Comment Set D01 Southern California Edison

Re: SCE's Comments on the Draft Supplemental Environmental Impact Report (SEIR) for the Devers-Palo Verde No. 2 Transmission Line Project – Colorado River Substation Expansion

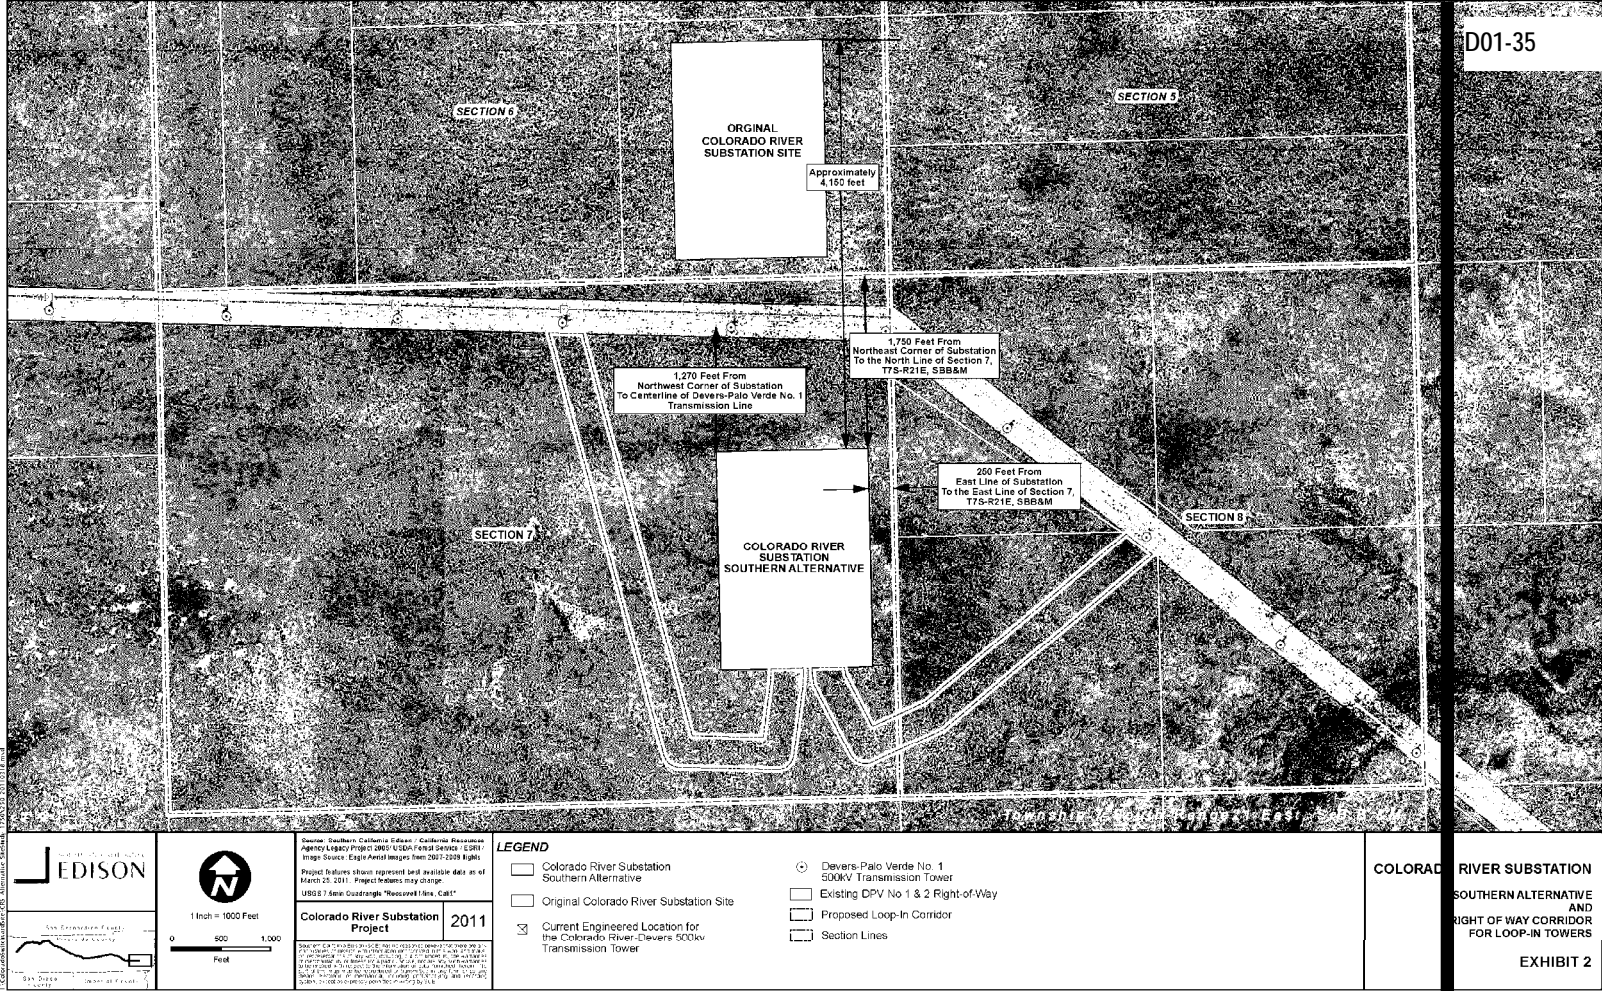
No	Section/ Appendix	Page	SEIR Text Revision or SCE Comment	Justification
23.		D-111 & D-113	<p>The SEIR (page D-107/8) states that existing water service providers have sufficient supply capacity to meet the needs of the approved DPV2, with no need for new or expanded water facilities. This is especially true since SCE plans to install a well at the CRS, which would reduce or eliminate the need to draw from the existing wells.</p> <p>Based on information provided in the SEIR, there are no documented wells near the site. The nearest documented well is approximately 4,800 feet northwest of the proposed project well location. As indicated in the SEIR (table D.4-5), drawdown of the nearest well to the project, based on an estimate of the construction needs and aquifer transmissivities, would be about 2.59 feet. Therefore, pumping of the proposed groundwater supply well would not result in a decline of more than 5 feet to the nearest documented well to the site. In addition, the SEIR threshold for significance (page D-101) states that a significant impact would occur if the project “Substantially depletes groundwater supplies or interferes substantially with groundwater recharge such that there would be a net deficit in aquifer volume or a lowering of the local groundwater table level (e.g., the production rate of pre-existing nearby wells would drop to a level which would not support existing land uses or planned uses for which permits have been granted.”</p> <p>Based the information in the SEIR and the fact that the SCE well(s) would have less of an effect on other nearby well compared to using those wells to supply water for construction, the SCE well would not result in a significant impact to groundwater wells, and therefore long term groundwater monitoring should not be required. SCE is requesting that mitigation measure H-7b be removed because there is no significant impact.</p> <p>In addition, regarding the production and groundwater information submittals in Mitigation Measure H-7b, groundwater information can be obtained from the SCE production well at the site. Pump testing of the supply well will be conducted to determine specific capacity which can be used to determine the rate the well can be pumped to maintain a level above the 234 foot Colorado River accounting surface. Well level monitoring during well production can be conducted to verify that the well level does not go below the Colorado River accounting surface.</p> <p>Water quality monitoring can be conducted by sampling the supply well for Total Dissolved Solids (TDS) on a periodic basis. During</p>	<p>Drawing water from an SCE well(s) at the CRS would replace water drawn from nearby wells, as discussed in the DPV2 Final EIR. This, in conjunction with the minimal effects on nearby wells (the closest of which is 4,800 feet) listed in Table D.4-5 demonstrates that no significant impacts to other water wells occur and long term monitoring is not warranted as described in Mitigation Measure H-7b.</p>

D01-35 Exhibit 2, which depicts the Southern Alternative and the right-of-way corridor for the transmission loop-in towers, has been incorporated into Appendix 1 of the Final Supplemental EIR to update and replace the original Figure Ap.1-7.
